Clause 83E Module Stressed input signal generation (Comment i-101)

Mike Dudek QLogic

7/13/2014

Eye Height and Eye Width for high loss channel in draft 3.0

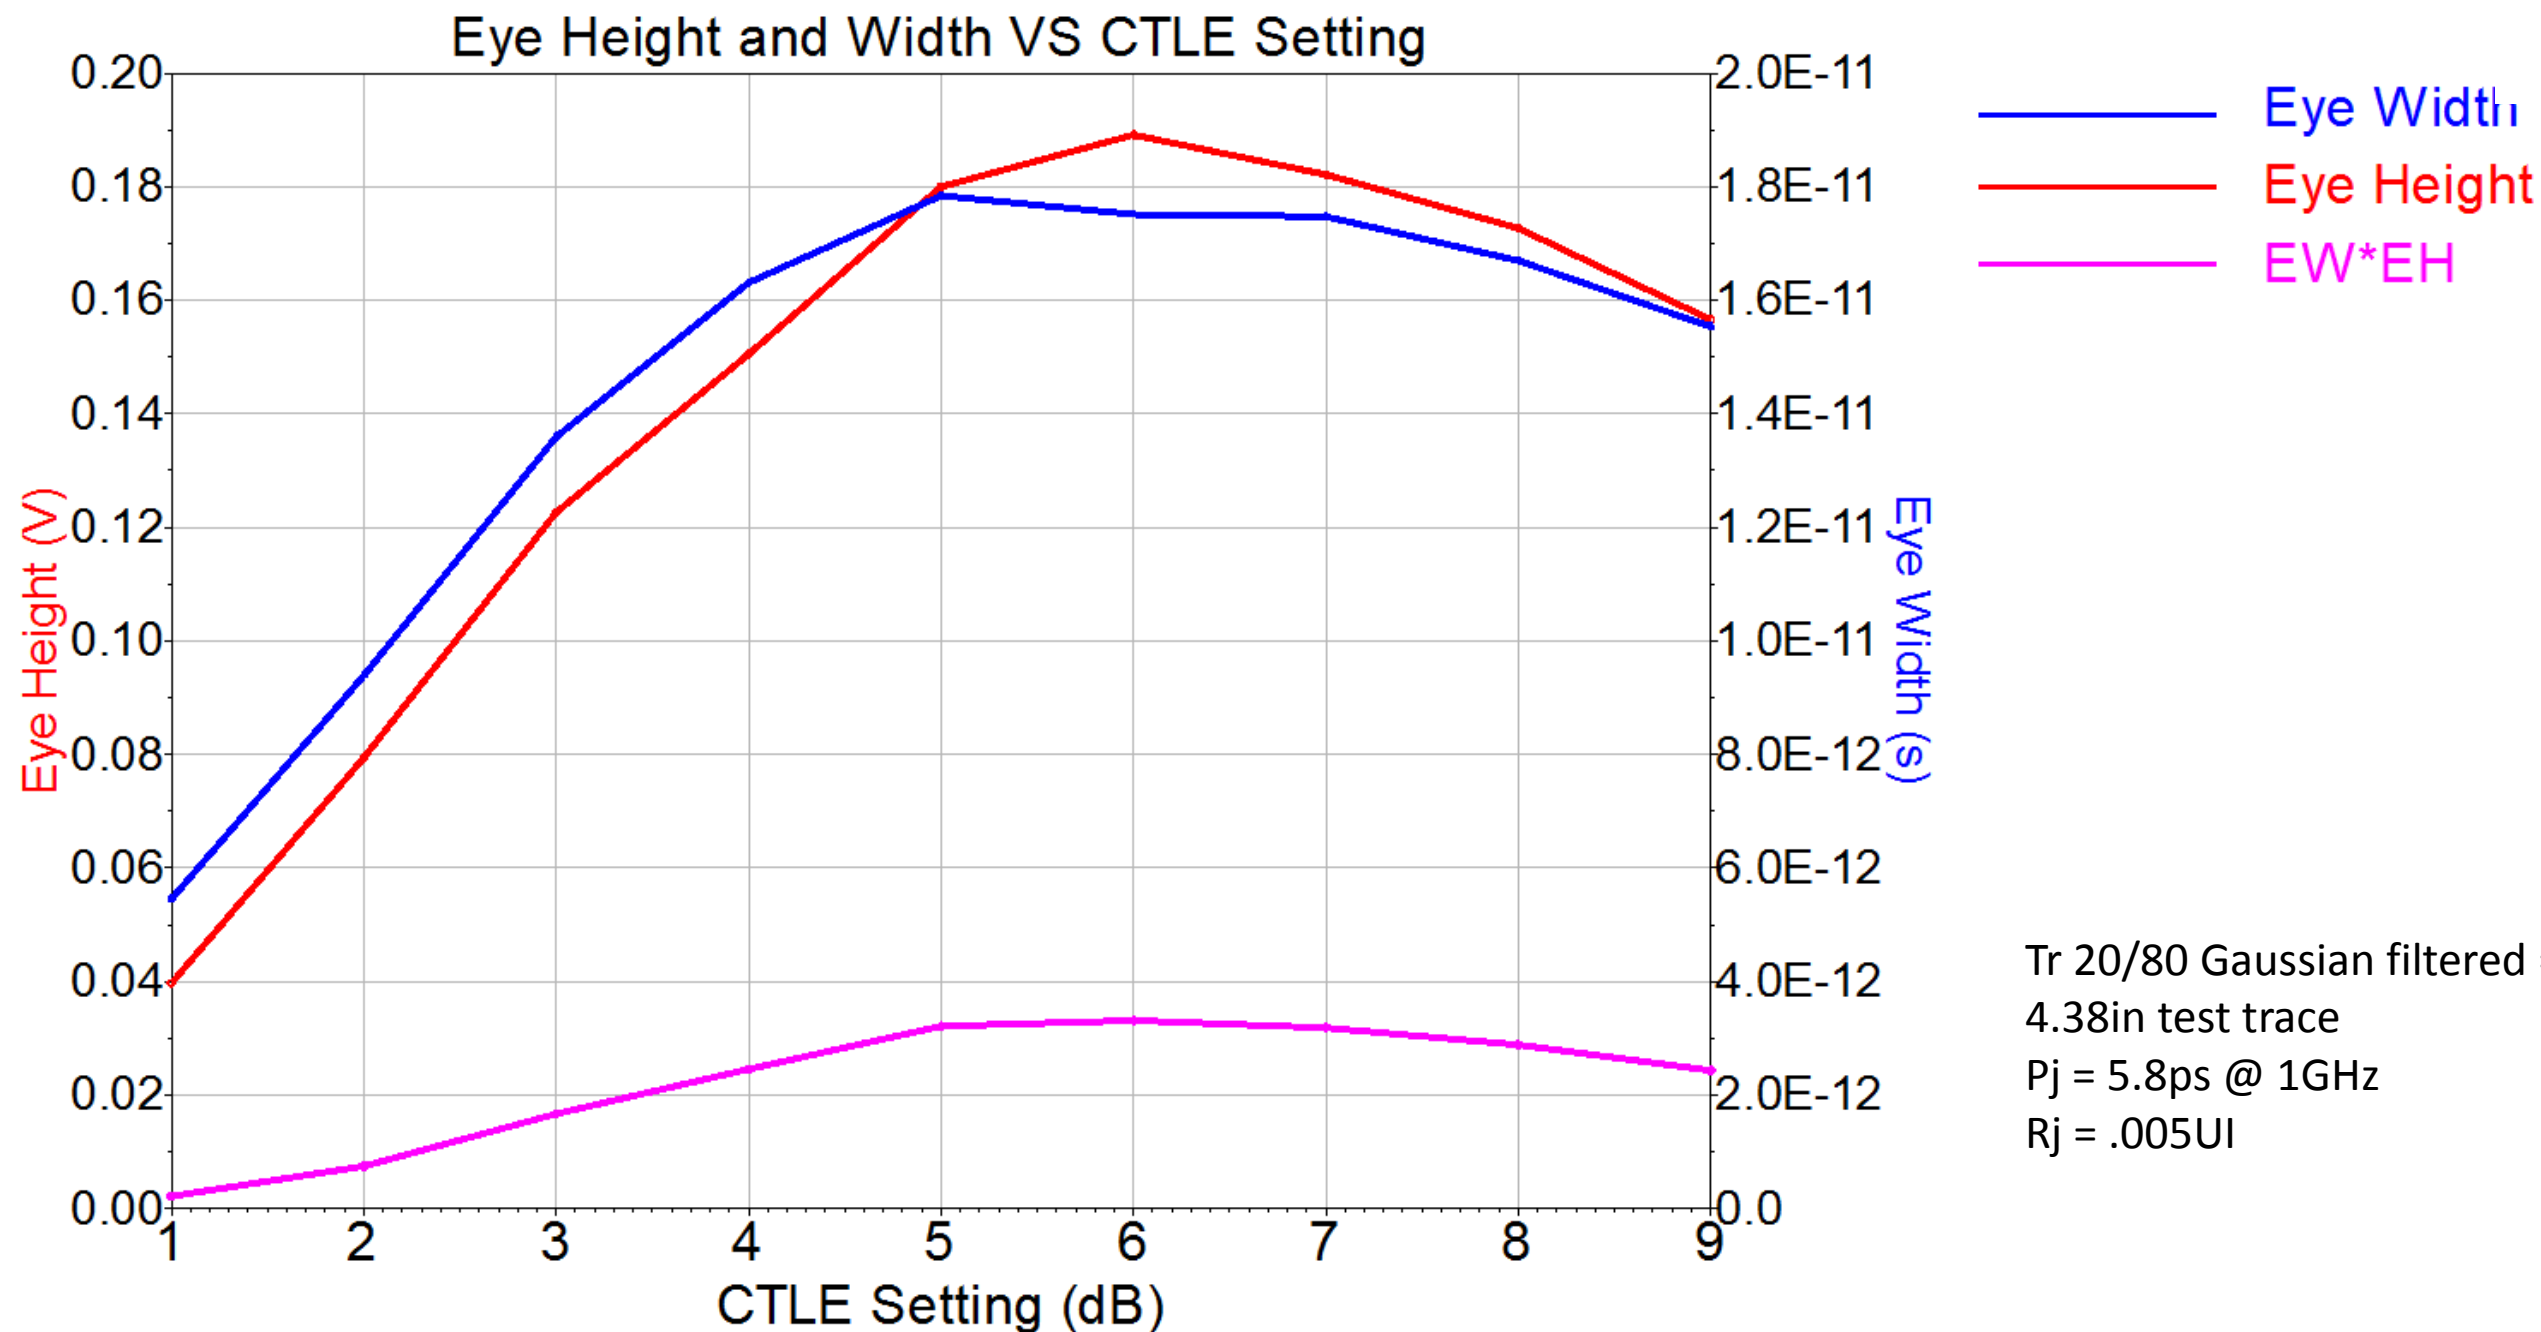
- **The “optimum” CTLE setting is only 6dB. This will not fully stress the module CTLE.**
- **We should create a stressed input that has an “optimum” CTLE setting of 8dB so that the module is tested with “recommended” settings of 7,8 and 9dB. Potential methods to increase the optimum CTLE are**
 - **Increase the test trace loss**
 - **Increase the transmitter risetime by reducing the bandwidth of the Gaussian filter.**
- **Secondary conclusion**
 - **The Eye width and Eye height are not a strong function of the CTLE setting provided it is large enough. This is relevant for other comments.**

With higher trace loss (13.8dB total channel loss).

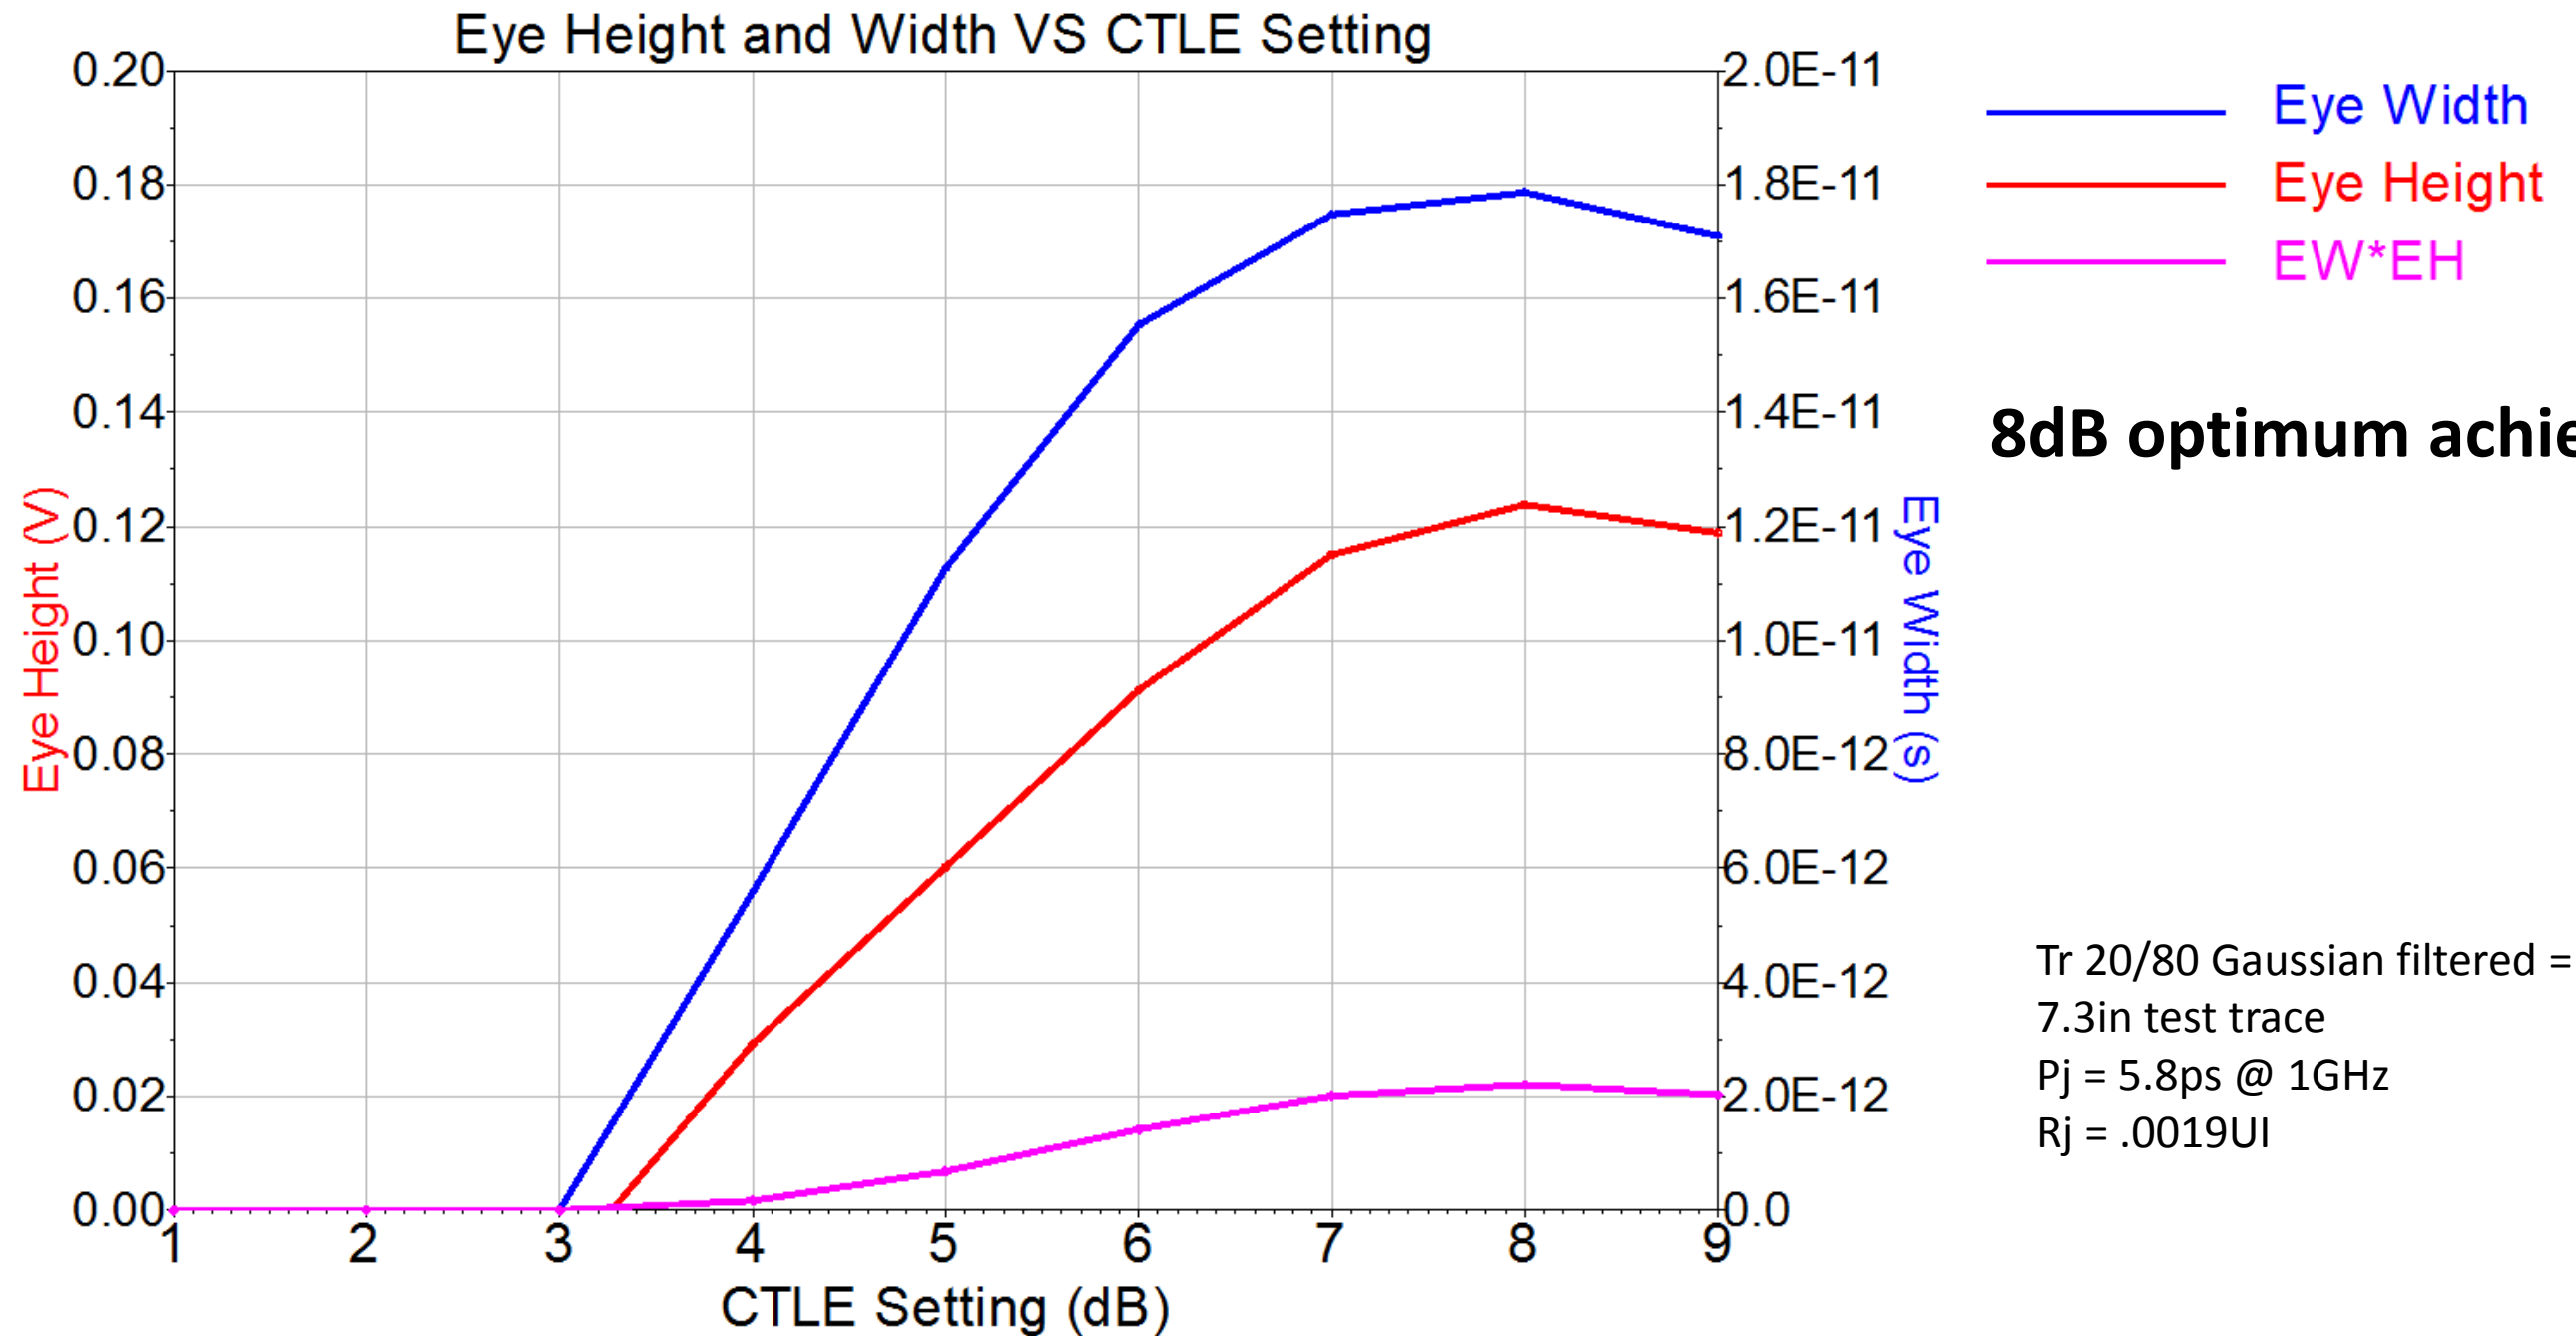
8dB optimum achieved

- **Increasing the risetime by reducing the bandwidth of the Gaussian filter does not have the desired effect (8dB for the optimum CTLE setting)**
- **We should increase the loss of the frequency dependent attenuator for the high loss case to achieve a channel loss of 13.8dB instead of 10.2dB. This will be equivalent to higher loss traces in the host ASIC package than present with the 9.5ps risetime pattern generator.**

With slower Gaussian filtered risetime (14ps) draft 3.0 channel

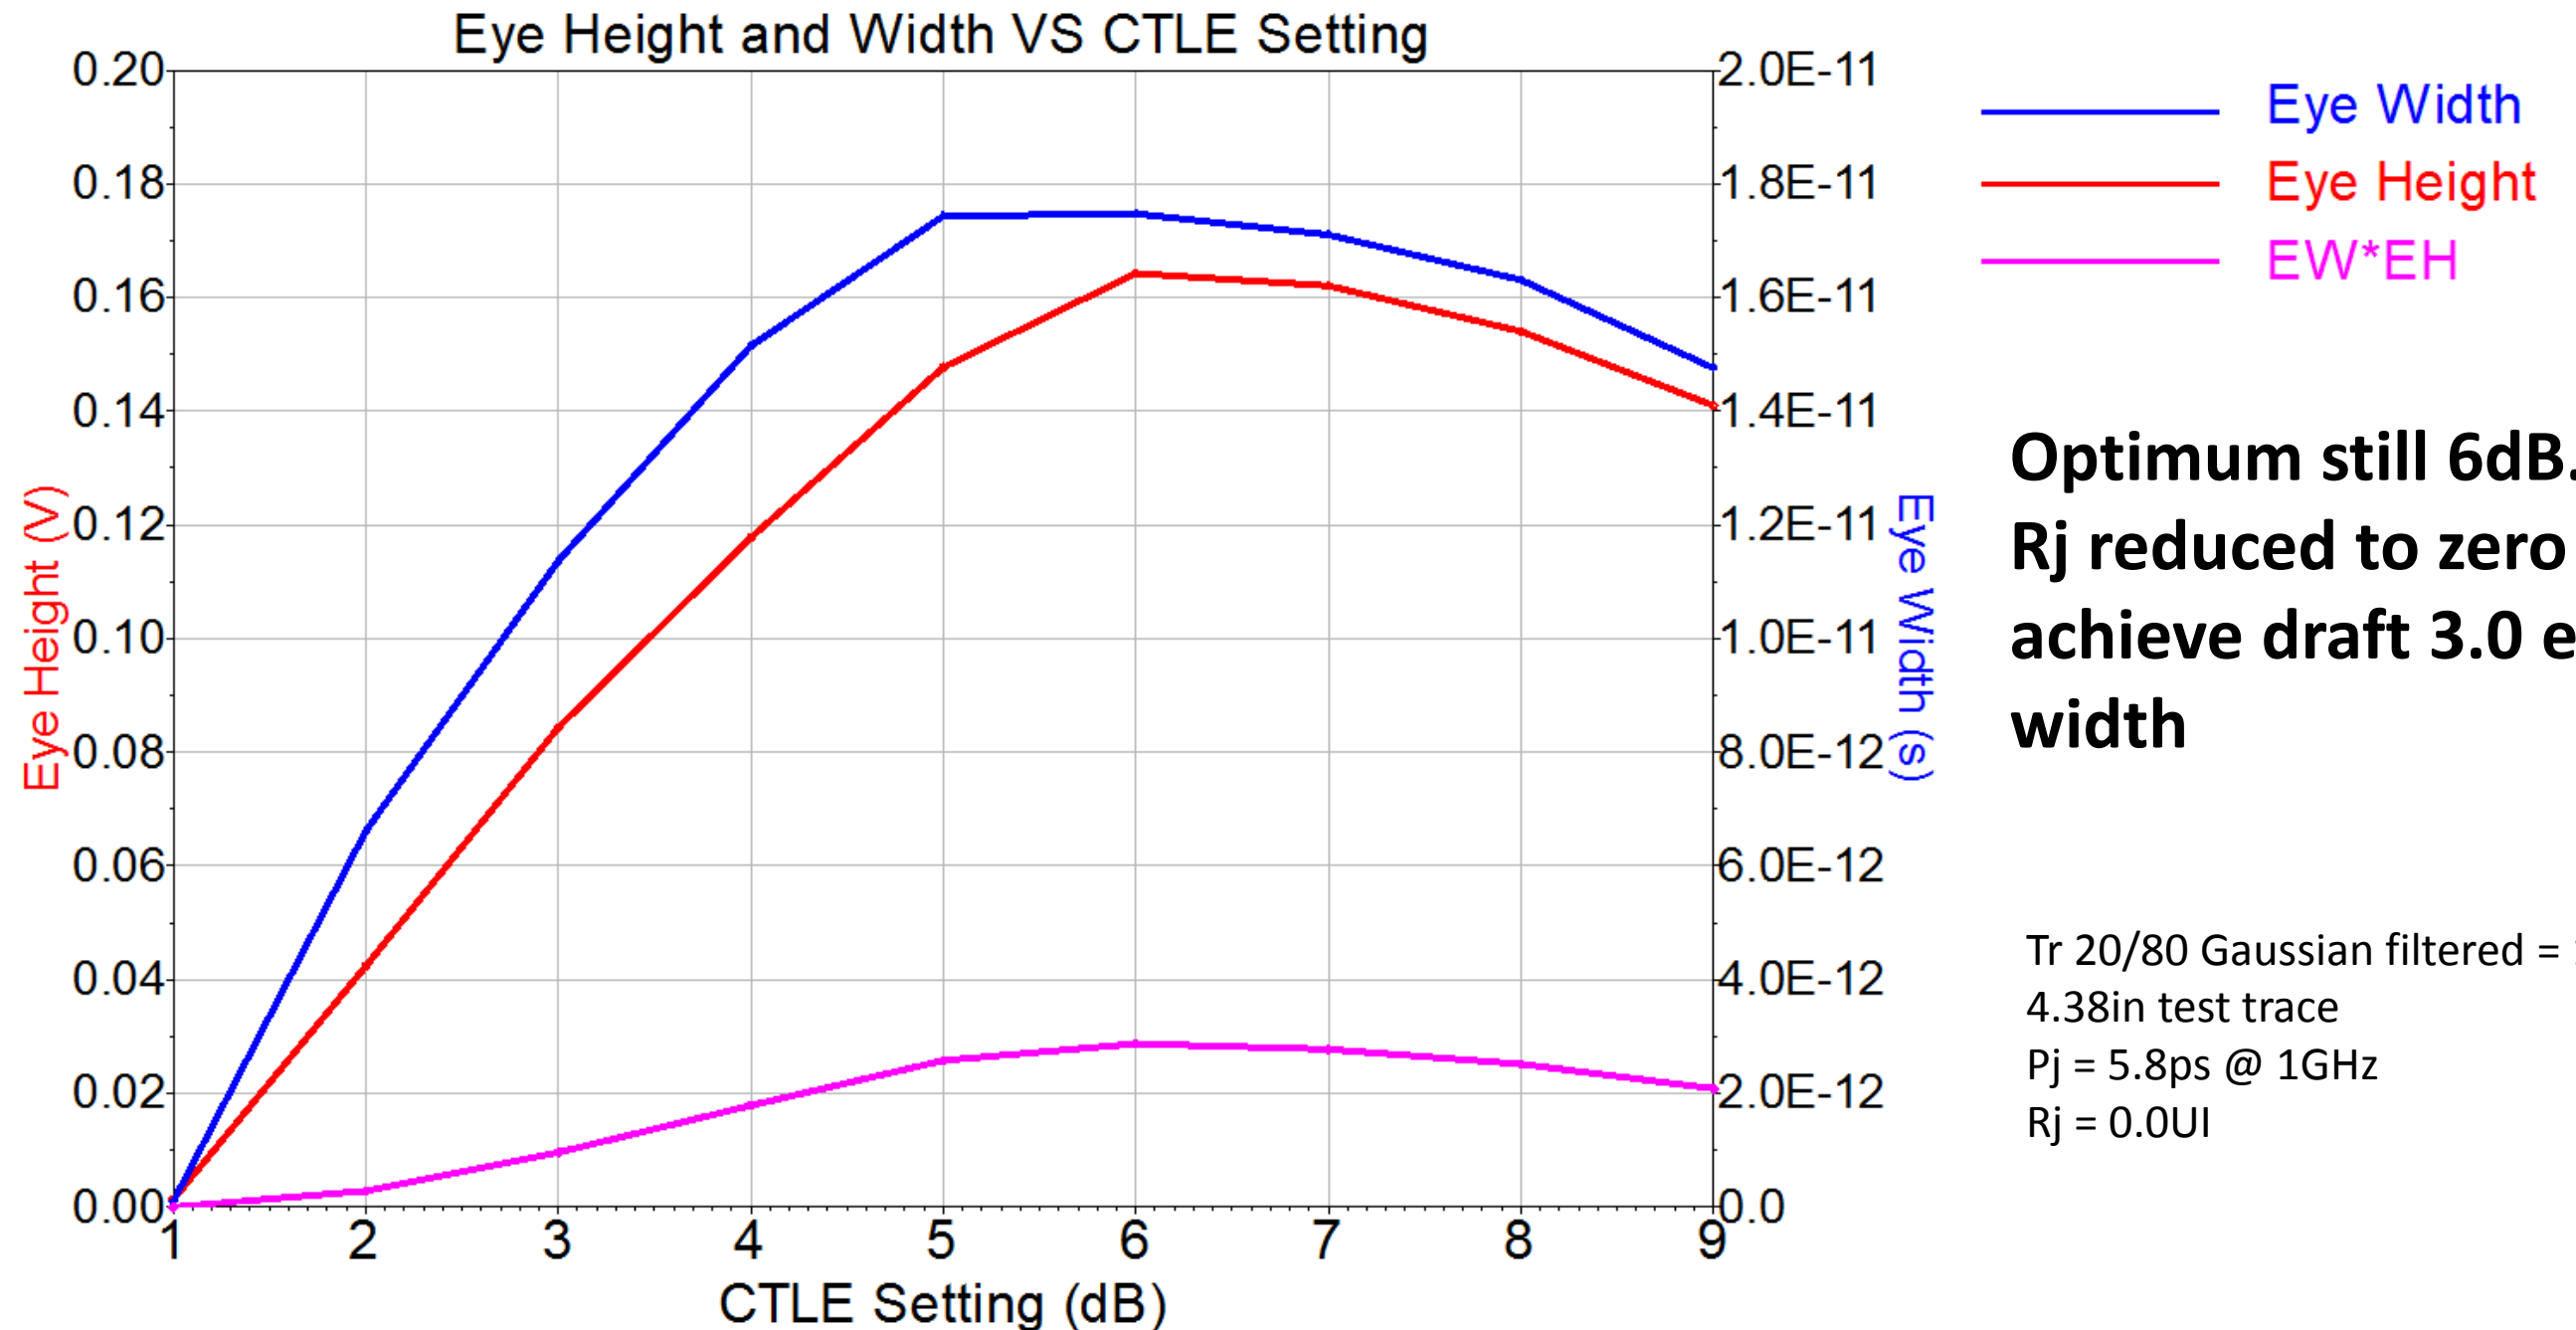
**Optimum still 6dB.
Rj reduced to zero to
achieve draft 3.0 eye
width**
